DEVELOPMENT APPLICATION

Primary Property Lot & DP	28 - 32 Dumaresq Street GORDON NSW 2072 Lot 1 DP961448, Lot 1 DP 103163 & Part Lot 1 DP 949218
Additional Property(/ies) Lot(s) & DP (s) Proposal	No related land Demolish existing improvements and construct a residential flat building containing 34 apartments, basement carpark and landscaping. This proposal also includes a Draft Voluntary Planning Agreement and explanatory note.
Development application no. Ward	DA0501/12 GORDON
Applicant Owner	Australia Wenzhou Group Property Pty Ltd Australia Wenzhou Group Property Pty Ltd & Ku ring gai Council
Date lodged Issues	29/11/2012 Provision of adequate deep soil landscaping to satisfy KPSO provisions; Removal of external loading/turning area to improve landscape amenity; Insufficient on site car parking to satisfy KPSO provisions.
Submissions Land & Environment Court Recommendation Assessment Officer	Yes N/A Approval Anne Moore Consultant Planner

The purpose of this report is to determine DA0501/12. The matter is reported to the JRPP for determination as the development proposed is for a residential flat building with a capital investment value of more than \$5 million (i.e. \$13,601,07

Figure 3- Proposed western envelope of building

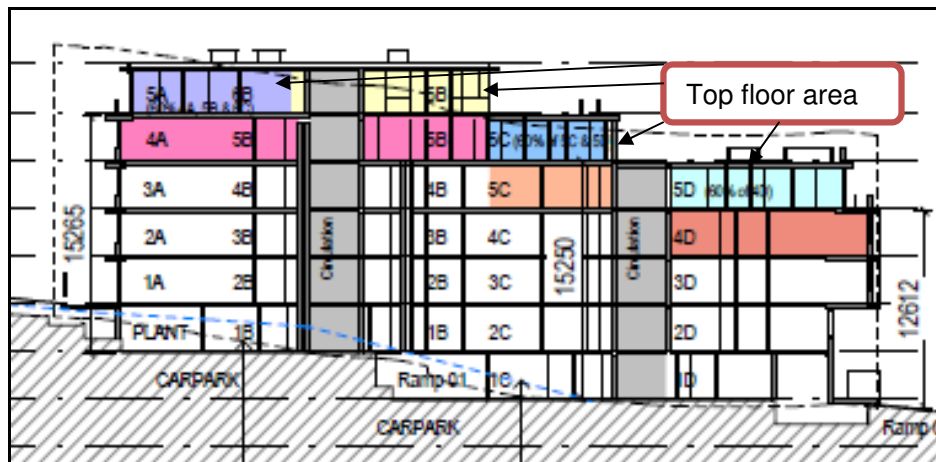
The proposed building is of a stepped nature as demonstrated by **Figure 3** below and the top floors of each section of this building are less than the 60% maximum limit and hence satisfy this provision.

The proposed development is described as 5 storeys plus a top storey of less than 60% of the floor below. Refer to **Figure 3** above for further details. The proposed development relies upon the steep slope provisions provided by Clause 25K in order to achieve the proposed building height.

Figure 4 – Lower ground floor level

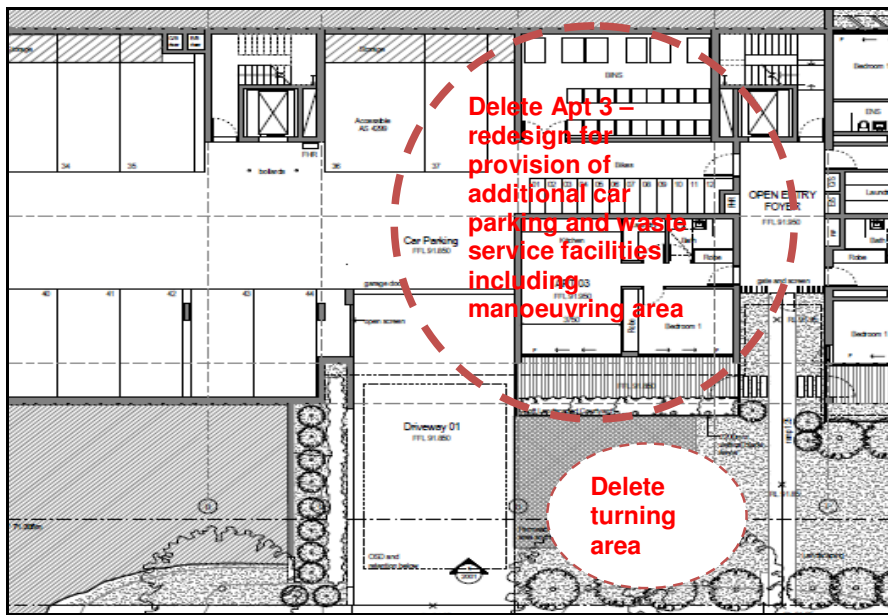
- Whilst parking has been provided within two basement levels, these basement levels extend past the building footprint above and therefore reduce the area available for deep soil landscaping particularly along Dumaresq Street;
- Unless modifications are undertaken to this development proposal as suggested within this report the proposal would not satisfy the objectives of KPSO in that the desired landscape character of the site and municipality will not be achieved; and
- This development proposal could readily be modified with the reduction of one apartment at lower ground level allowing for the provision of one additional parking space due to the reduction in unit numbers, adequate waste storage facilities with an appropriate internal turning area and eliminating the loading/ turning area adjacent to driveway 1 and providing deep soil landscaping to satisfy KPSO provisions.

The variation to the parking standard within KPSO is not supported in this case for the reasons outlined above. It is recommended in **Condition 19** that Apartment 3 at the lower ground level be deleted which is a one (1) bedroom apartment with relatively poor amenity given its single westerly aspect, its positioning adjacent to driveway 1 and overlooking a turning/loading area. The deletion of this apartment would result in one less parking space being required pursuant to the KPSO. The car parking area at this lower ground level could readily be redesigned to provide one additional parking space, adequate waste storage area and an internal turning area for deliveries and waste collection. Refer to **Figure 4** for further details. Council's engineer supports this recommendation. The external turning/loading area could then be suitably landscaped.

Figure 5 – Western elevation

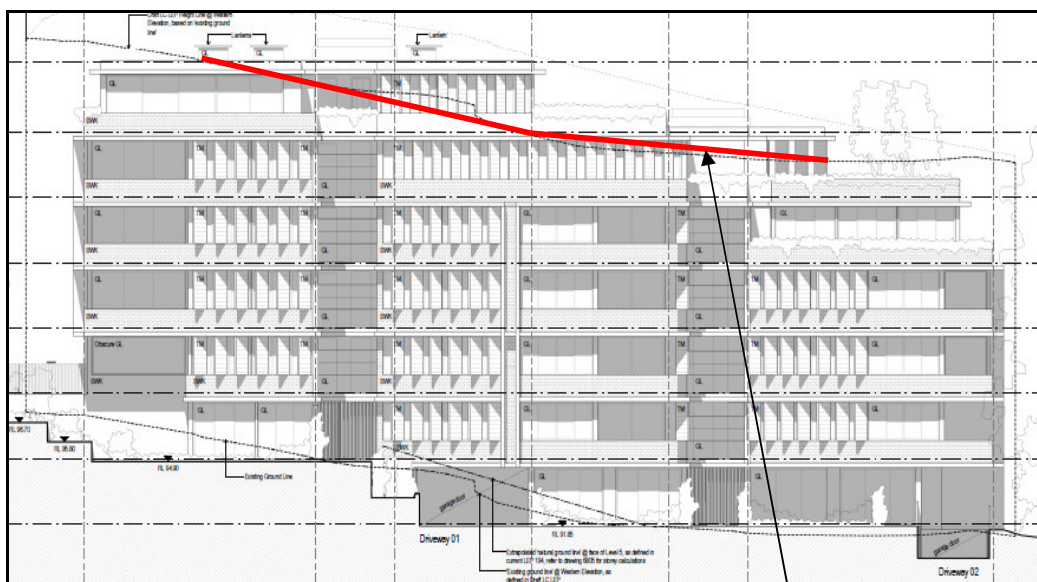
The proposed building has a maximum height of 20.8 metres which exceeds the height limit of KLEP (Local Centres) 2012 by 1.4 metres to 3.3 metres for the middle section of the western elevation of the proposed building as demonstrated by **Figure 5** below. This non compliance is attributed to the topography of the site that slopes from front to rear and which is also affected by an east to west crossfall. The eastern elevation of the proposed building satisfies the height limit. It is emphasised the proposal has been designed to comply with Clause 25 – Rail Corridor and St Ives Centre provisions of the KPSO, which has a complex set of provisions relating to the number of storeys and ceiling heights to control the height of buildings.

Furthermore, the proposed building has been designed to follow the topographic characteristics of the site and the western elevation when viewed from the new road comprises three distinctive vertical elements and is well articulated building with inclusion of numerous openings, balconies, projections, etc. The overall scale and built form is consistent with other residential flat buildings along Dumaresq Street and appropriate for this high density residential locality of Gordon. As the proposal is located at the end of a row of residential flat buildings, it will act as a block end and be a transitional site between high density residential flat buildings to the east and separated by a new road to adjoining low density residential areas to the west. Consequently, the variation to this height control is considered acceptable in this case.
